FPL

St. Lucie Units 1 and 2
Docket Nos. 50-335 and 50-389

Florida Power & Light (FPL)/St. Lucie's Fifth Overall Integrated Plan Status Report in Response to March 12, 2012 Commission Order Modifying Licenses with Regard to Requirements for Mitigation Strategies for Beyond-Design-Basis External Events (Order Number EA-12-049)

Figure 1 PSL FLEX Electrical Connections (Unit 1) (Rev 0A)

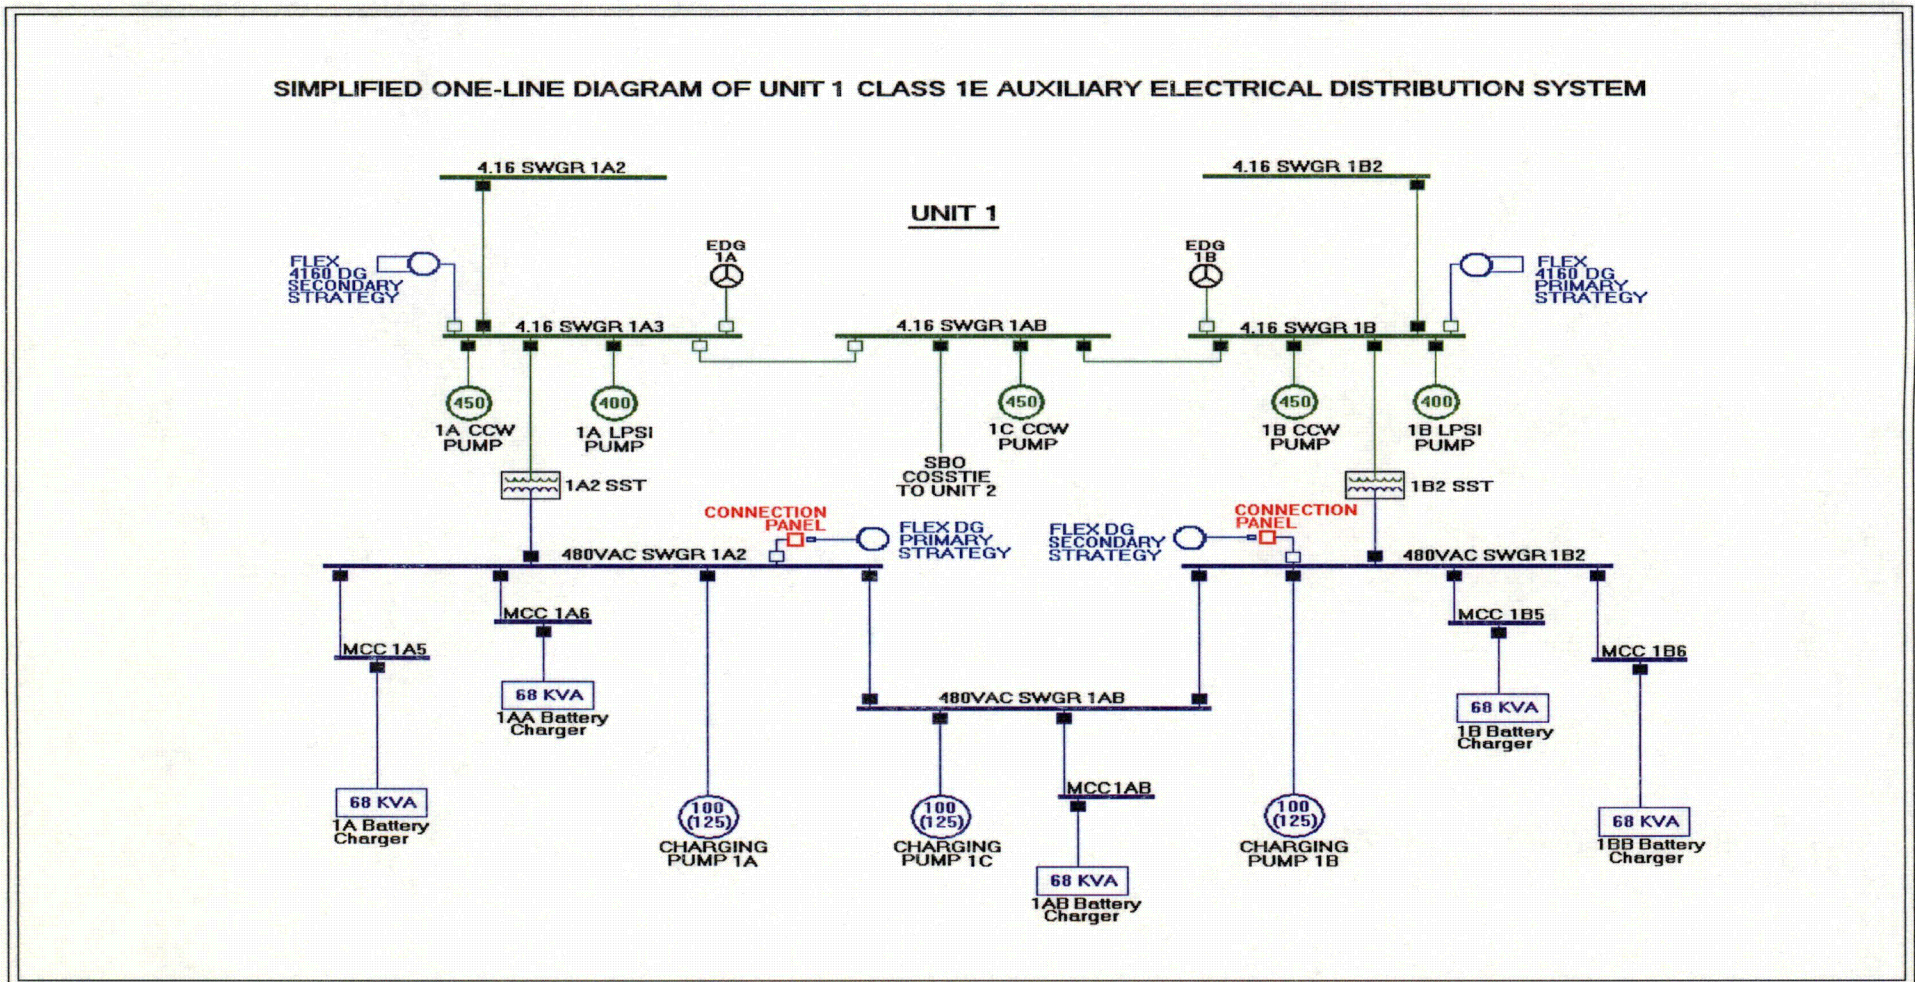
The St. Lucie FLEX strategy for making electrical system connections has evolved from that indicated in the Reference 1 response figures to be consistent with NEI 12-06 guidance (Reference 4). Refer to attached final revised electrical connection figures. Note the 480 volt connections will now be made using procedurally controlled breakers rather than using transfer switches.

Figure 11 Connections for CST FLEX Pump Suction on CSTs (Rev 1)

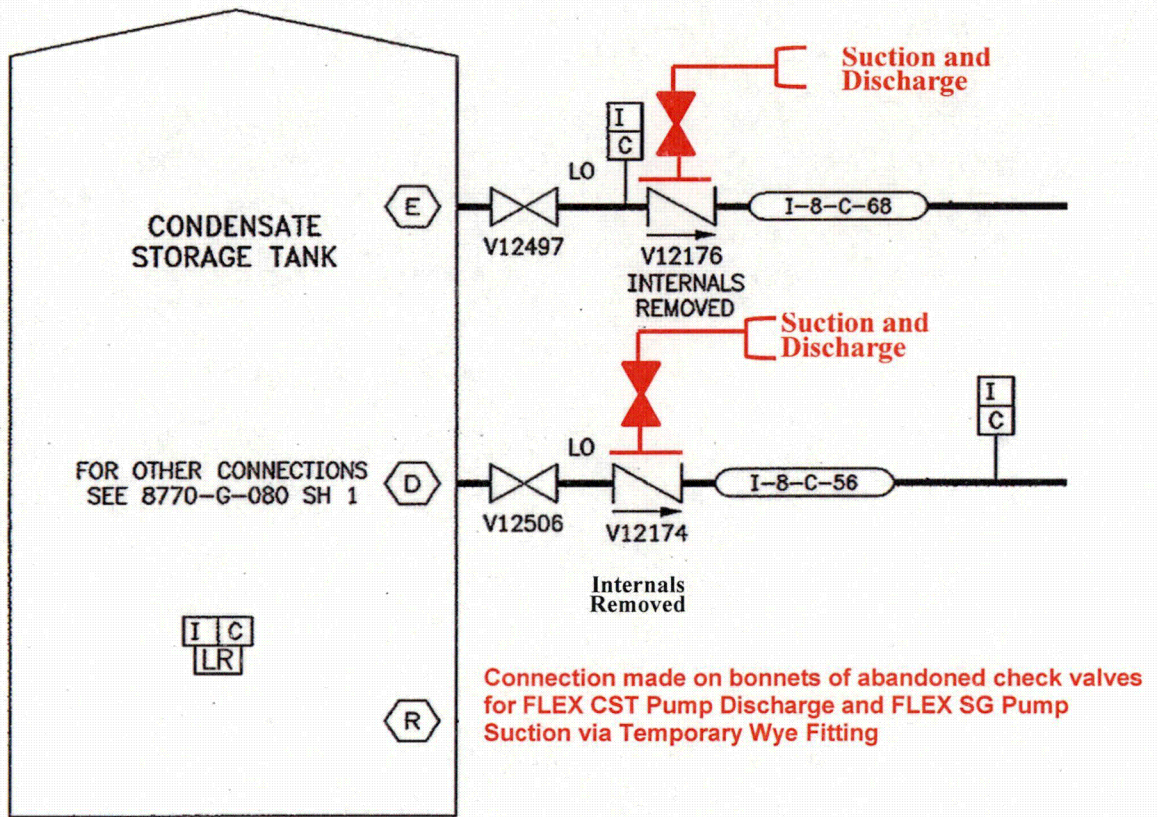
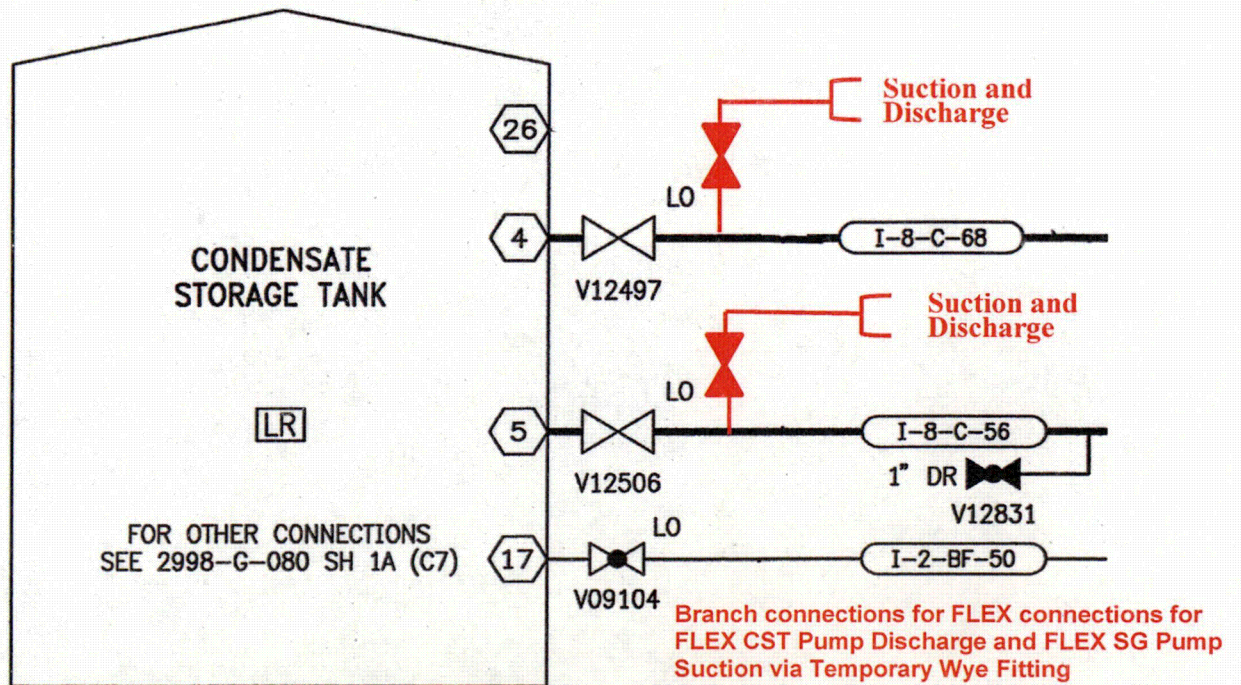
The St. Lucie FLEX strategy for making mechanical system connections has evolved from that indicated in Reference 1 response figures to be consistent with NEI 12-06 guidance (Reference 4). Secondary connections may require reconfiguration (e.g., removal of valve bonnet or disassembly of a flanged pipe joint) if validated that time and resources are reasonably available to support the reconfiguration. Locations of the connection points provide reasonable assurance that at least one connection will be available for all applicable hazards. Refer to attached revised mechanical connection Figures 11, 12 and 14 for the latest changes.

Figure 14 Connections for SG FLEX Pump Discharge to LPSI Pump Discharge Lines (Rev 1)

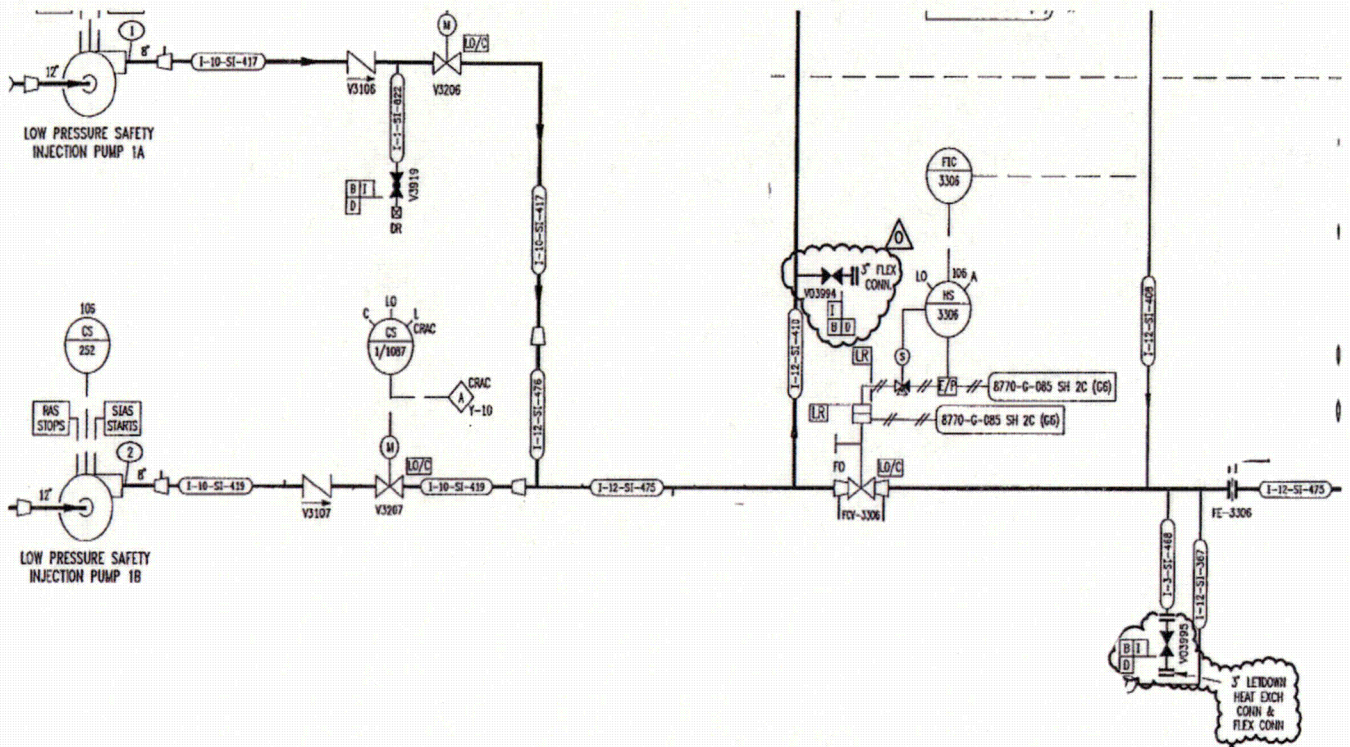
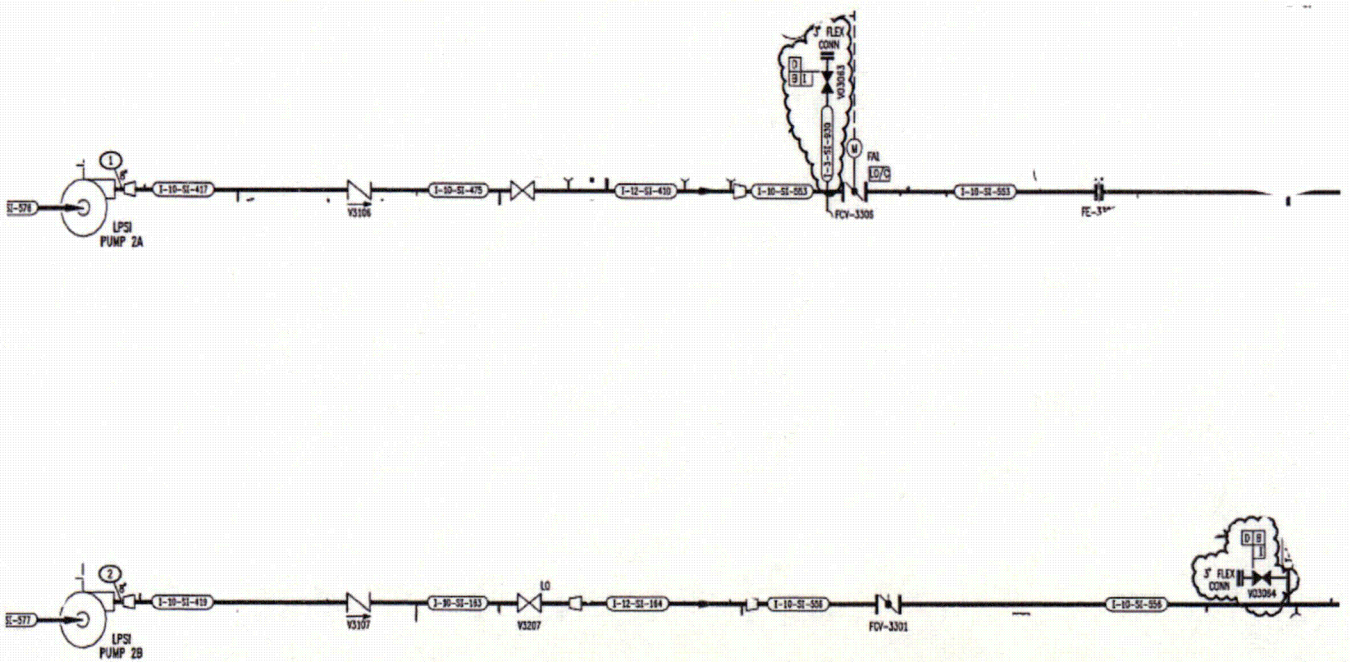
Install primary and secondary 3" isolation valves & hose connections on the LPSI 1A/1B Pumps common discharge piping. For RCS cold leg injection with FLEX SG Pump drawing suction from the RWT.

Install 3" isolation valves and hose connections on each of the LPSI 2A & 2B Pumps discharge piping. For RCS cold leg injection with FLEX SG Pump drawing suction from the RWT.

Figure 22 Connection for SFP FLEX Pump Discharge to Fuel Pool Pump (Unit 1, Unit 2 Similar) (Rev 0)

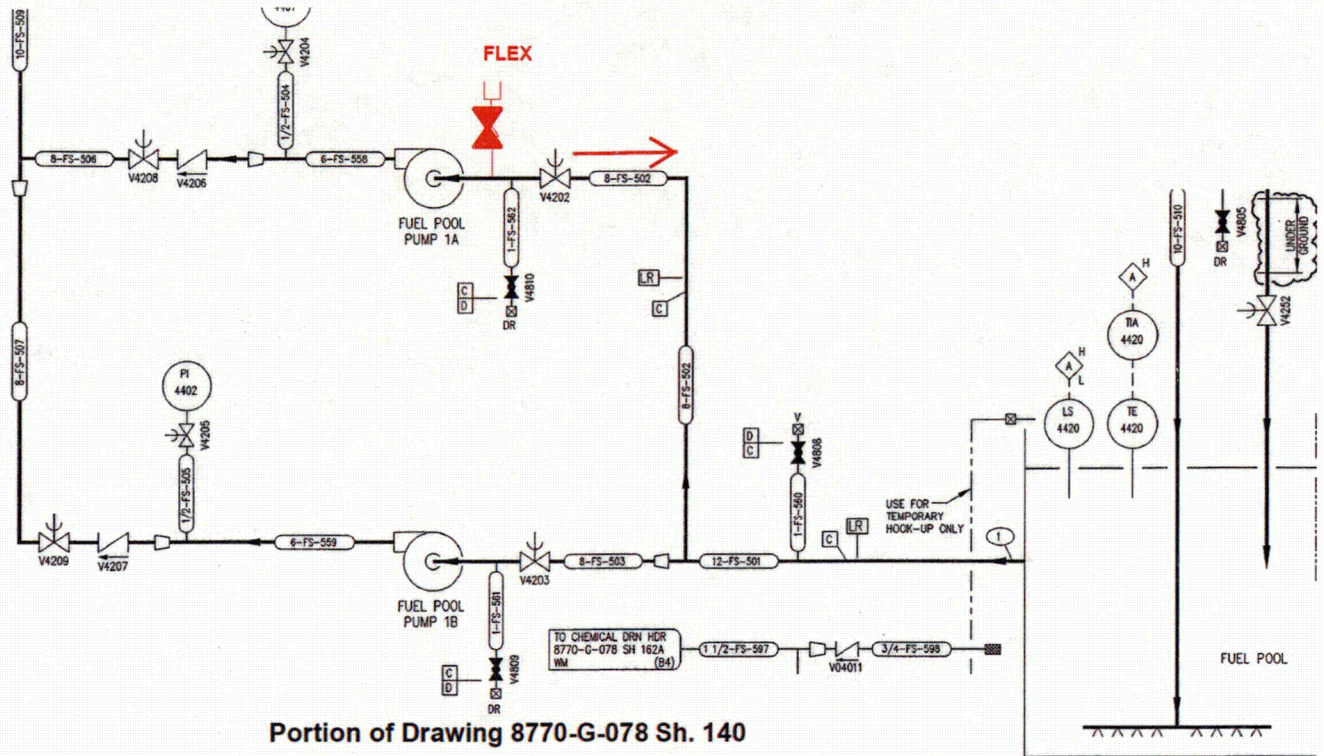
The Reference 1 FLEX response described the hardened makeup flowpath to Maintain Spent Fuel Pool Cooling as via the 2½" ICW lines on the exterior east wall of each Fuel Handling Building (FHB). In lieu of providing missile protection for these lines, an alternate missile protected flow path will be provided. The alternate path is via a new FLEX connection on the suction of one of Spent Fuel Pool Pumps on each unit. These lines and their flow paths to the Spent Fuel Pools are within the missile protected interior of the FHB's. The 2½" ICW lines remain the preferred hardpipe flowpath should they remain intact following the BDBEE. See new Figure 22.

**Install a 3" isolation valve and hose connection on SFP Pumps 1A & 2A
Suction piping. For SFP Hardened Makeup from FLEX SFP Pump**

Figure 23 Connections for Secondary Water Sources (Ft. Pierce Utilities) for SFP FLEX Pump Suction and FLEX CST Pump Suctions (Rev. 0)

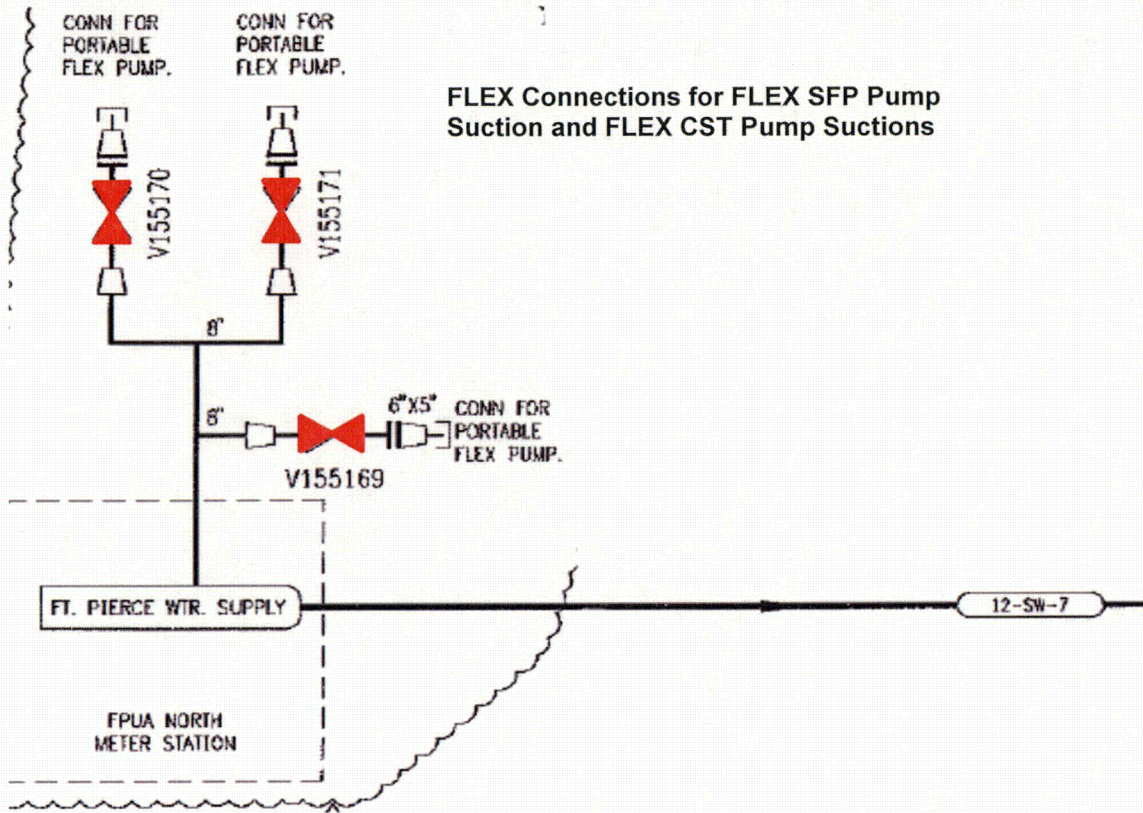
For a high wind-tornado based event, site tanks will be pre-filled, as required by administrative procedures. With respect to tornado winds and missiles, the Unit 2 CST volume is fully qualified and reference 18 provides reasonable assurance that the Unit 1 CST is tornado missile protected. Reference 18 also provides reasonable assurance that other major tanks (RWTs, CWSTs, TWST and PWSTs) are tornado missiles protected based on their design, separation and intervening structures; the CWSTs, TWST and/or PWSTs should be available as secondary sources of water to provide makeup to the CSTs/RWTs during Phase 2 following a high wind missile event. An alternate makeup water strategy credits the underground water supply line from Fort Pierce Utilities (FPU), the local potable water supplier. Rather than missile protecting the single existing source from tornado, a second source will be installed and separated by greater than diameter of typical tornado path (1200 ft) with that path oriented from the west to southwest. See new Figure 23.

Figure 24 Connections for Diesel Oil Gravity Drain Connections from Unit 2 Diesel Oil Storage Tanks (Rev 0)

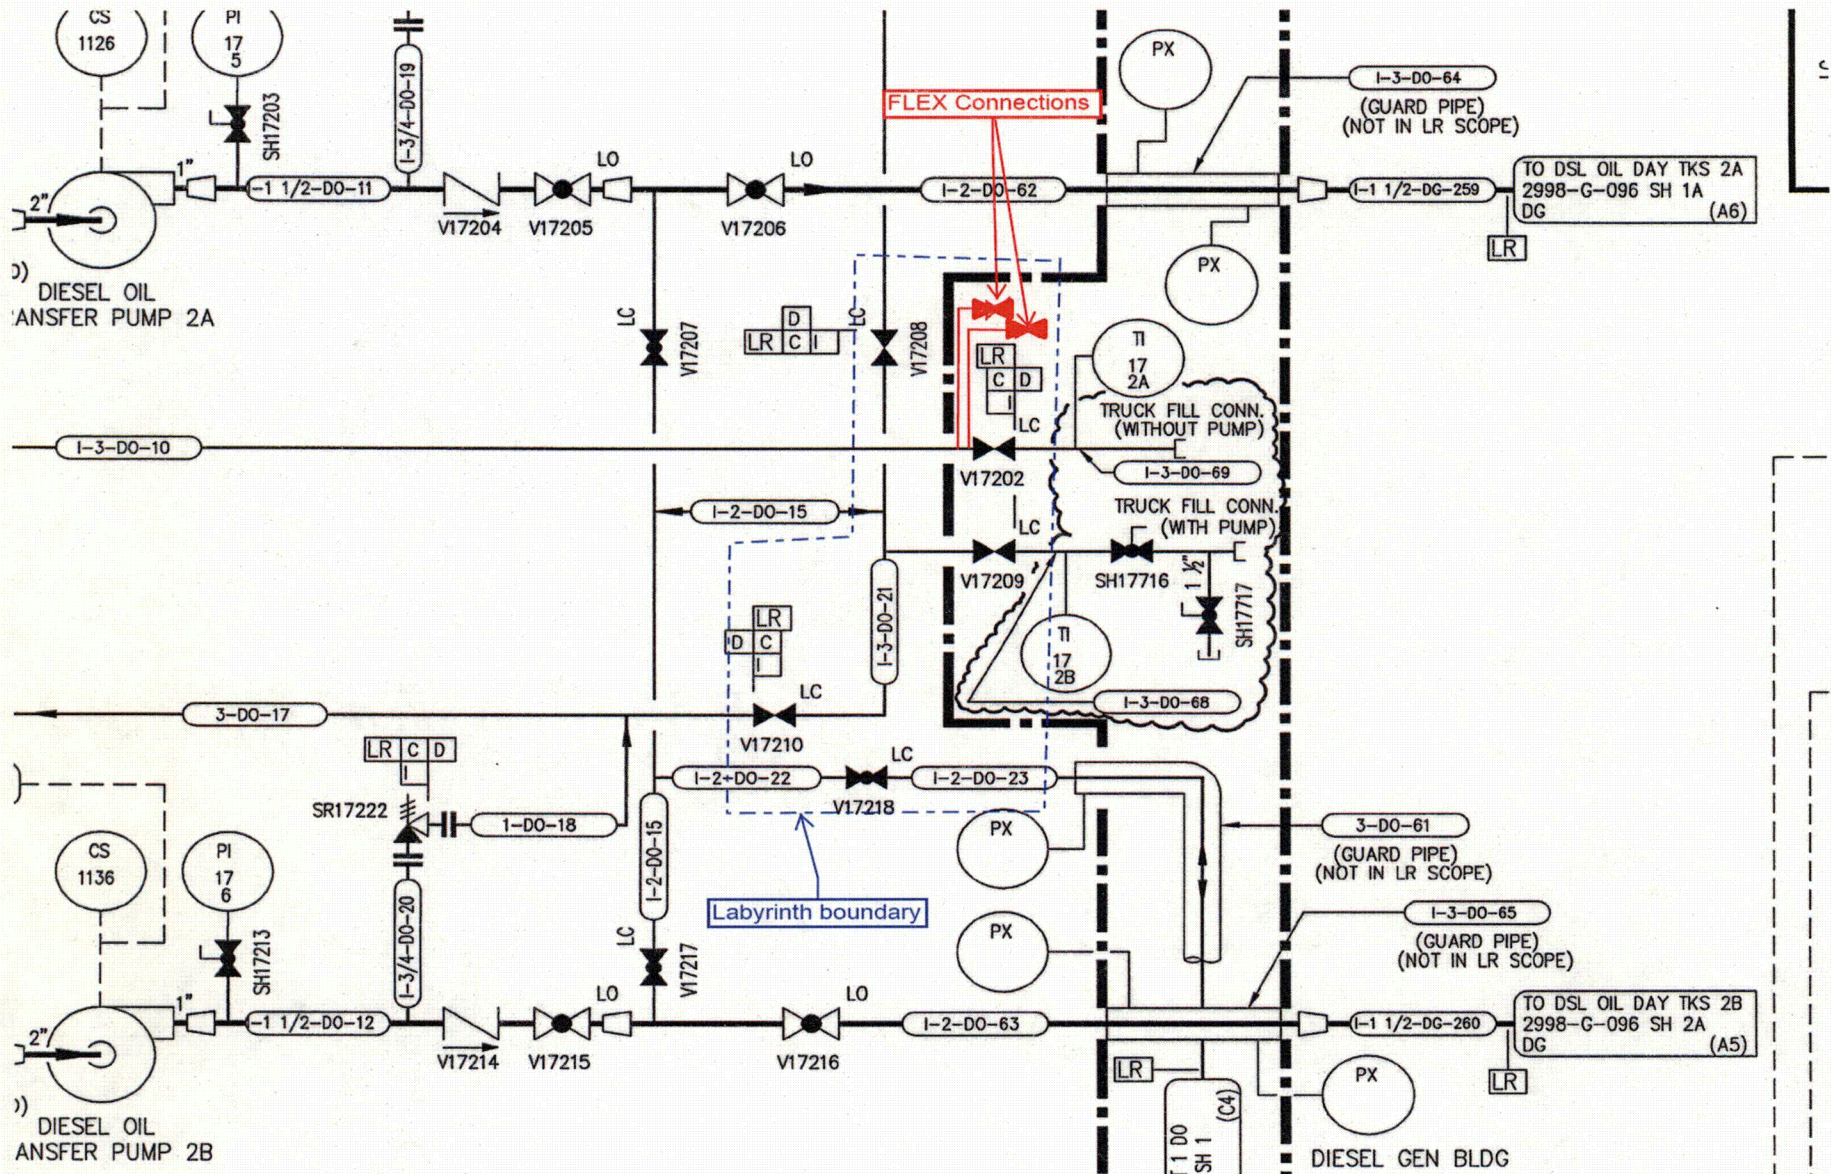
Note that the Reference 1 FLEX response stated the refueling of diesel fuel oil driven equipment will be accomplished via a trailer stored in the FESB, on which will be mounted a 500-gallon tank. The tank size has been evaluated and a 1000 gallon trailer mounted tank is being procured. Gravity fill of this tank has been revised to use V17202 or one of two new redundant valves that have been installed on the fill line. See new Figure 24.
